Commissioner Pat Keliher, Department of Marine Resources
c/o Ms. Amanda Ellis
dmr.rulemaking@maine.gov
Sent via electronic mail

January 29, 2021

Project Review: Weston Hydroelectric Project (#2325)

Donald Pugh

Figure 2. Percent exceedance at the Weston project (Madison and Mercer gages combined) and flows of 6,480 and 13,500 cfs, 2009 to 2020.

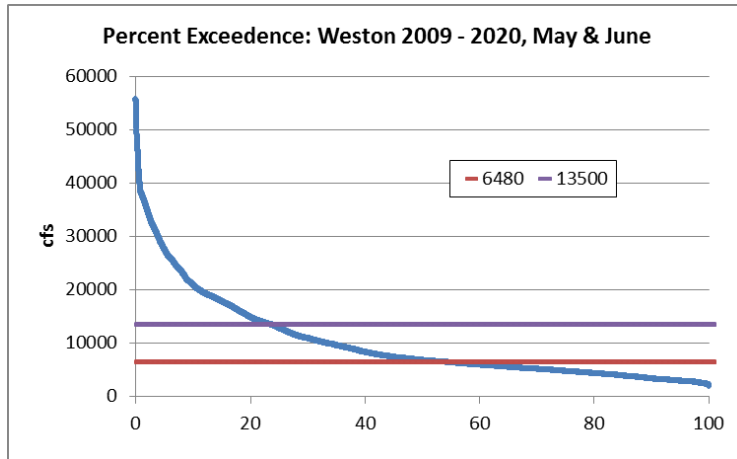
Figure 2 shows the percent exceedance for the years 2009 to 2020 and lines of 6,480 and 13,500 cfs, full generation plus 0.08% bypass flow and full generation plus full bypass flow plus one north dam Taintor respectively. [Madison gage data begins in 2009]

The primary problem with the fish lift at the Weston project is that the entrance to the lift is obscured during high flow. Full high flow in the downstream sluice and competing flow from the units will overwhelm attraction flow from the fish lift. At 8,500 cfs, all units will be a full capacity (6,000 cfs) and the downstream bypass will discharge 2,500 cfs. Appendix A shows those discharges combined with 2,400 cfs spill from the north dam. [8,500 cfs was not modeled] For the months of May and June, 8,500 cfs is exceeded 38% of the time and 11,200 cfs, the condition in Appendix A, is exceeded 28% of the time (Table 2).

- Spill from the north dam creates flow on the opposite side of the river from the fish lift. Fish that move to the north dam have no means of passing upstream at that location. False attraction created by spill at the north dam will occur when river flow exceeds 8,500 cfs (38.7% of May and June, Table 2).

Appendix A

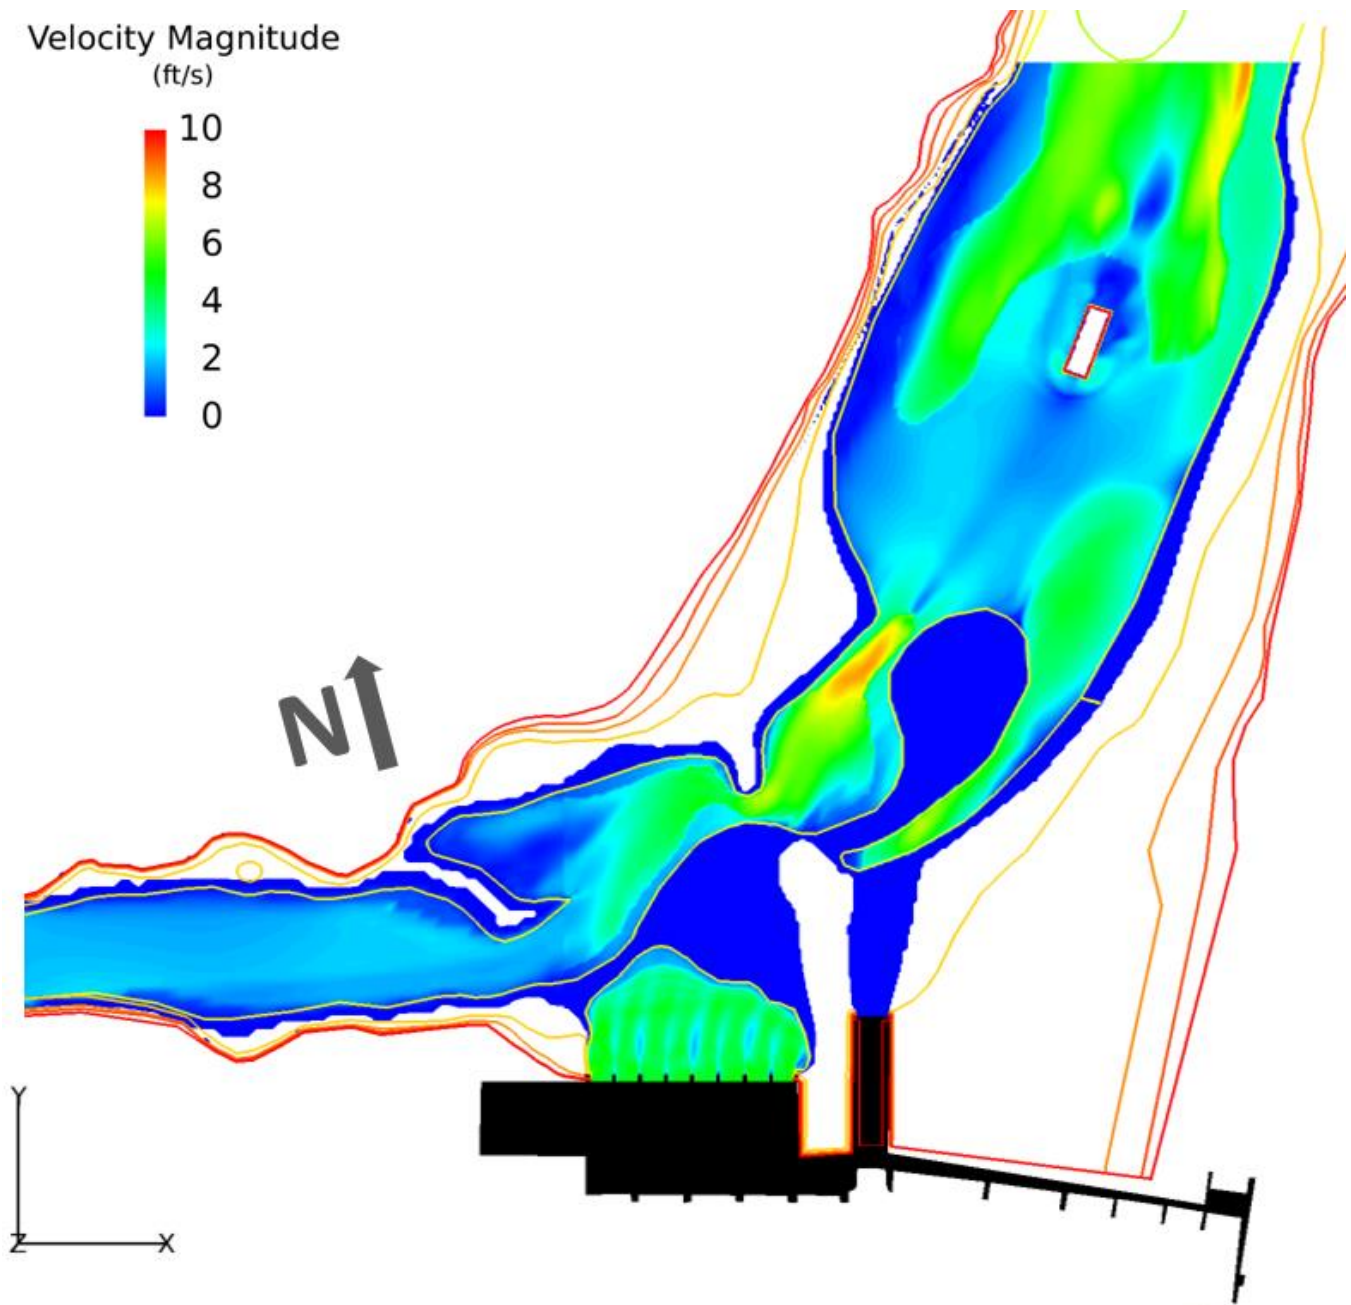
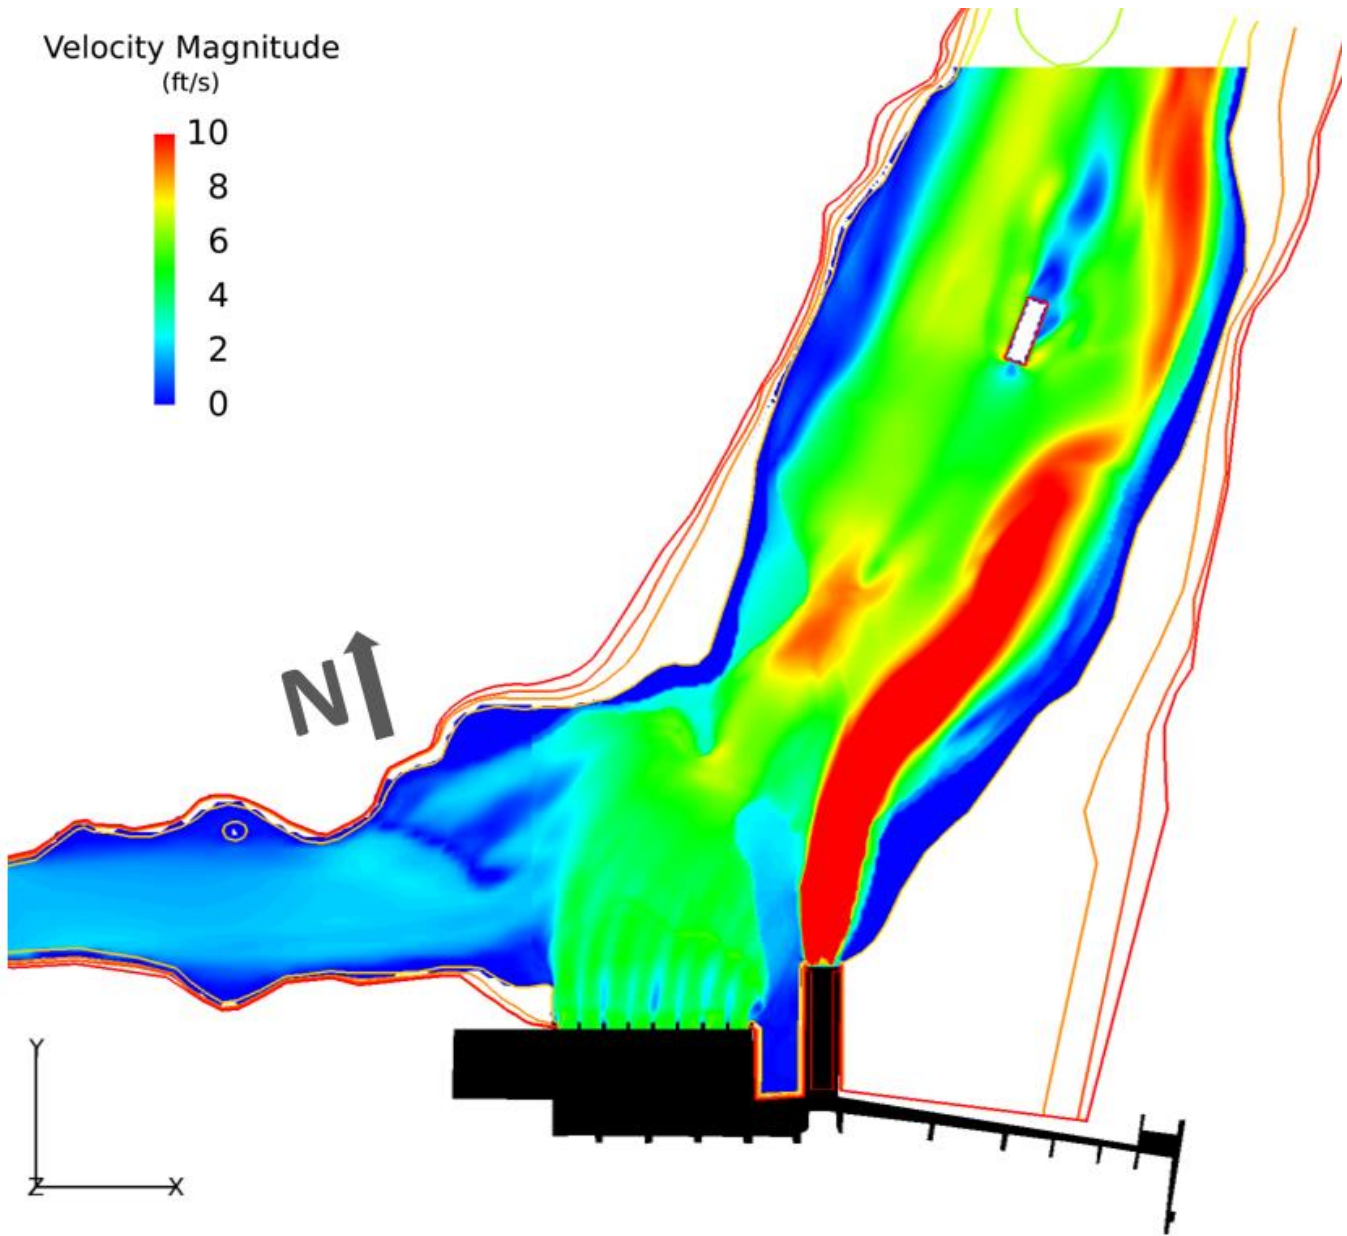
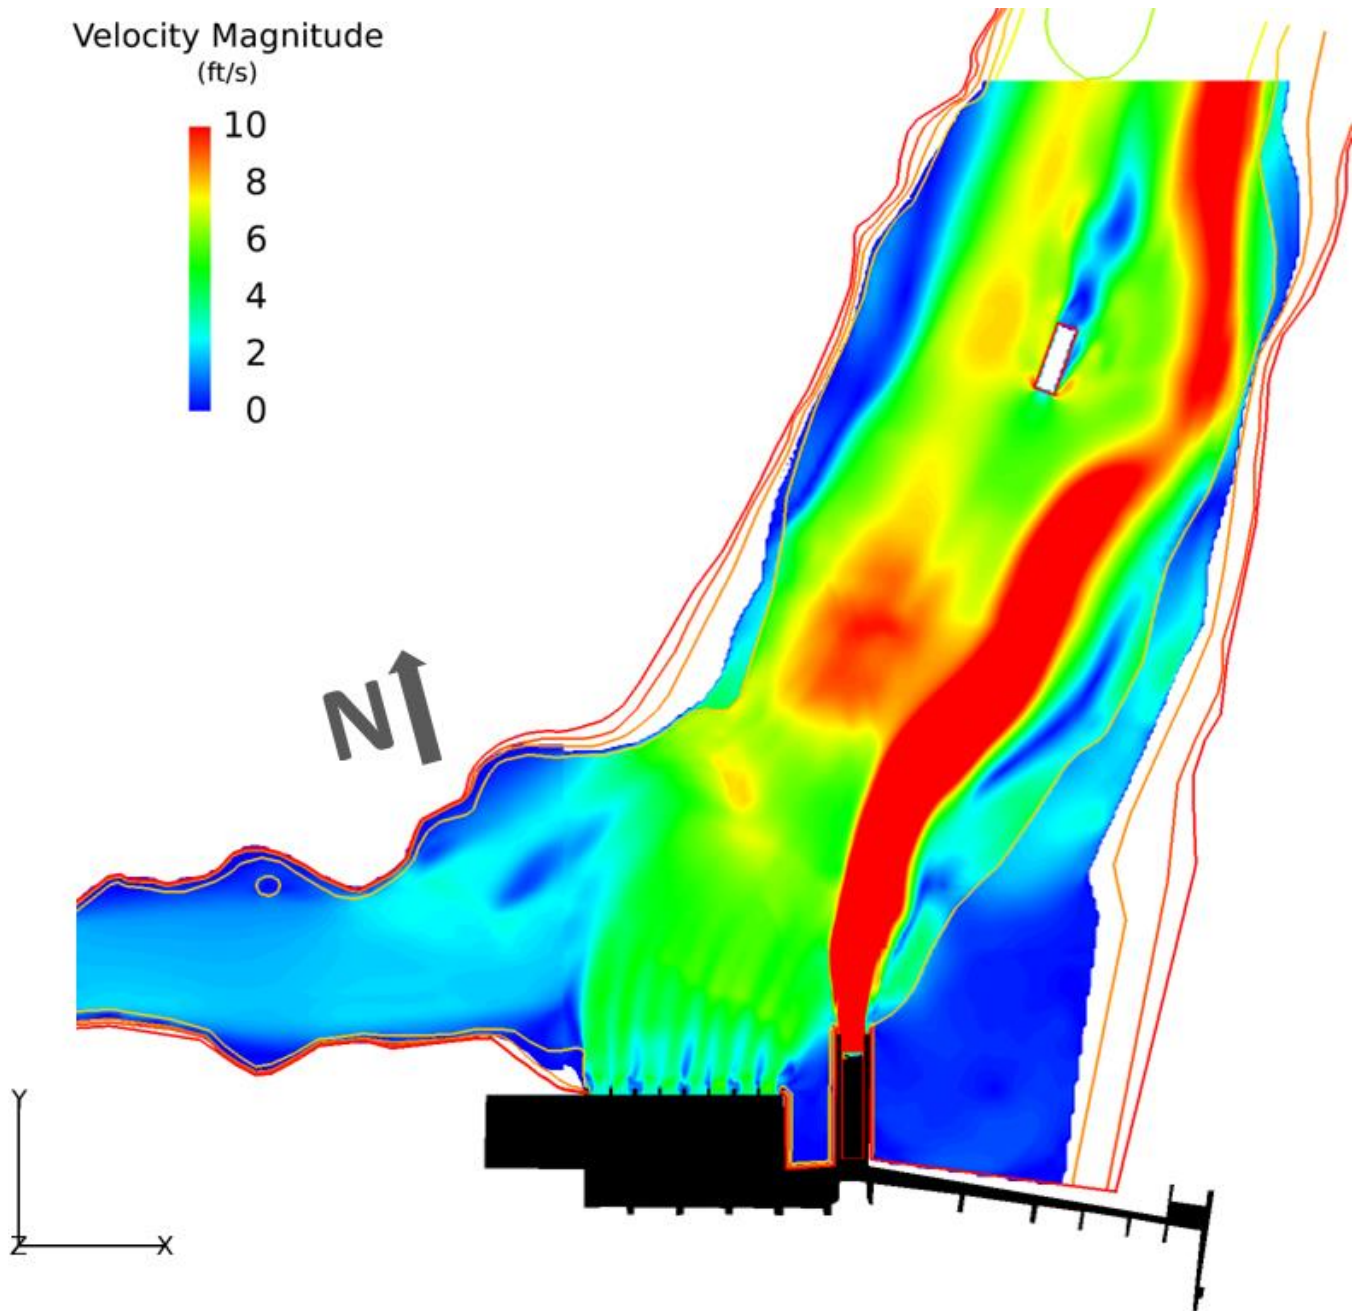
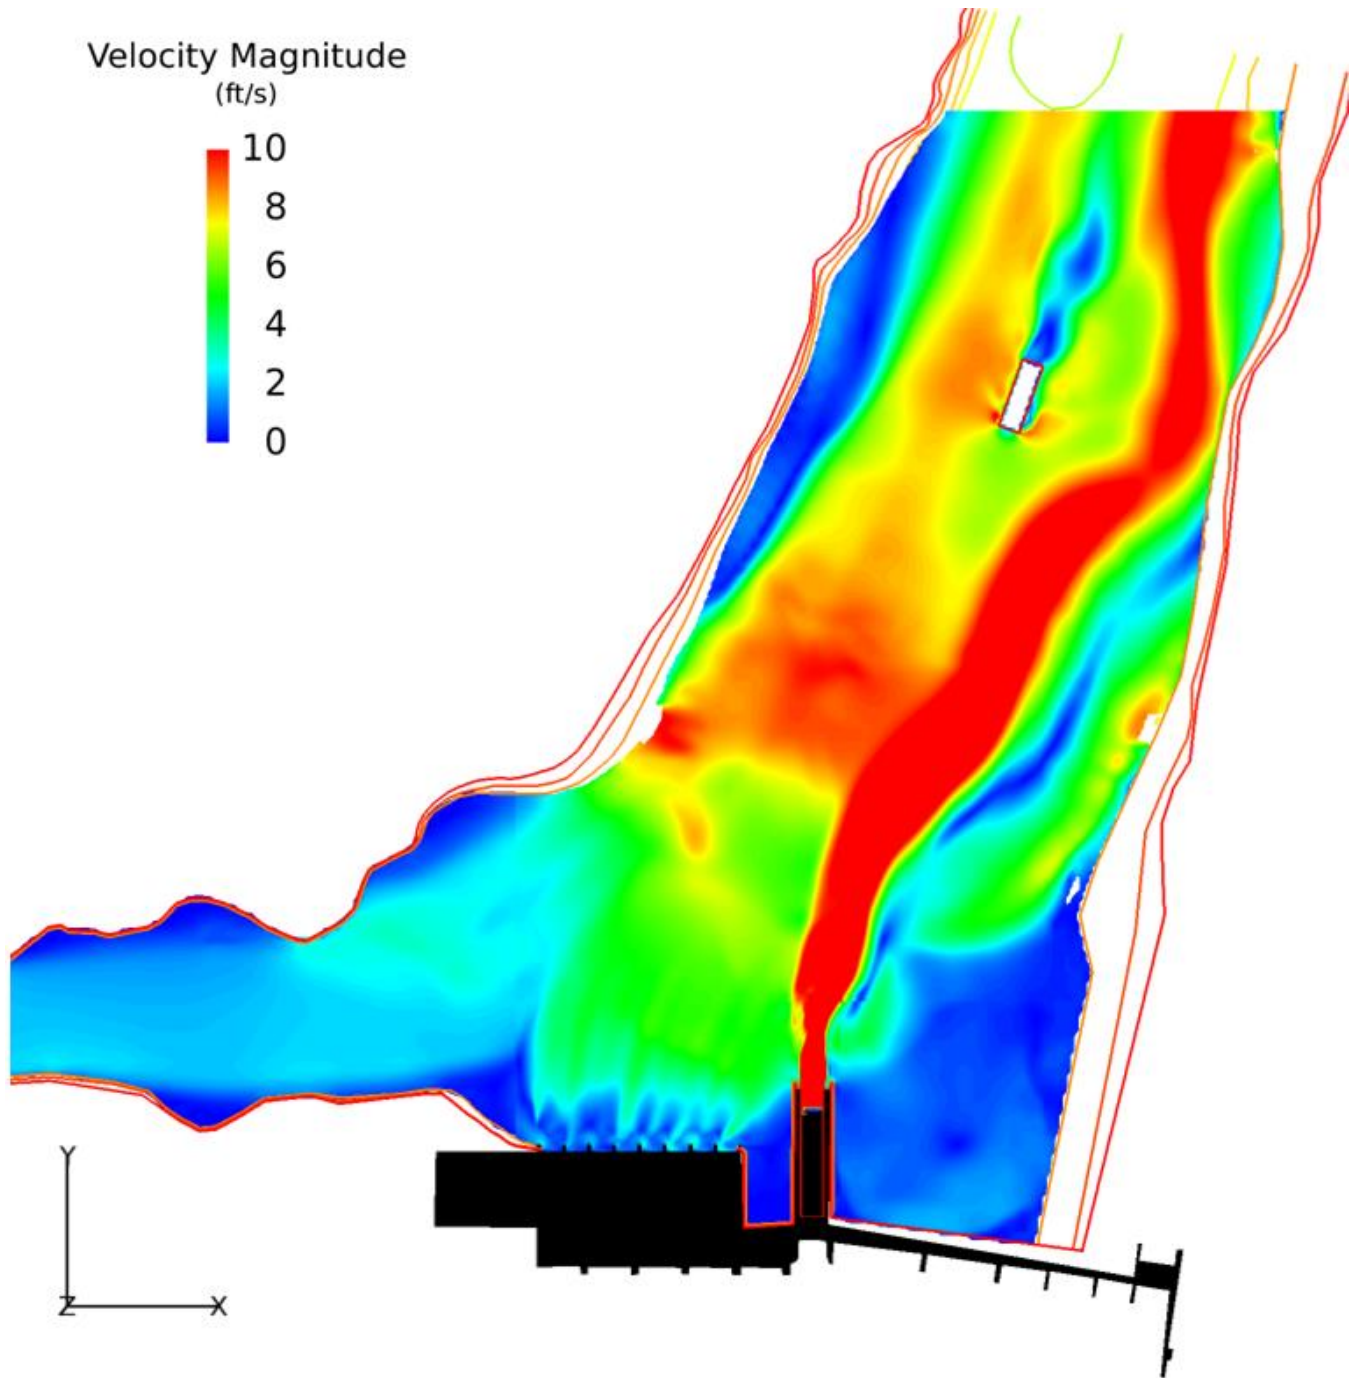
- Fish attracted to spill from the north dam that fall back will likely have difficulty finding the fish lift entrance as discharge from the units will be between them and the fish lift. Appendix A shows velocities of 4 – 6 ft/sec or greater across the powerhouse.

- At river flow of 8,500 cfs or greater, fish moving upriver on the south side (river right) need to cross a wide and deep high velocity jet from the downstream sluice to reach the fish lift entrance. Velocities with 2,500 cfs in the sluice are greater than 10 ft/sec and extend downriver past the footbridge creating a barrier to fish moving to the lift entrance (Appendix A).

- CFD study shows high flow (>6 cfs) dominate the center of the river at a river flow of 11,200 cfs with large areas with velocities >10 ft/sec.

- With whole river flow of 8,500 cfs (4 units plus 2,500 cfs downstream bypass) flows of greater than 10 ft/sec extend downstream past the footbridge (~475'). High velocities may result in fish not reaching the lift or being delayed.
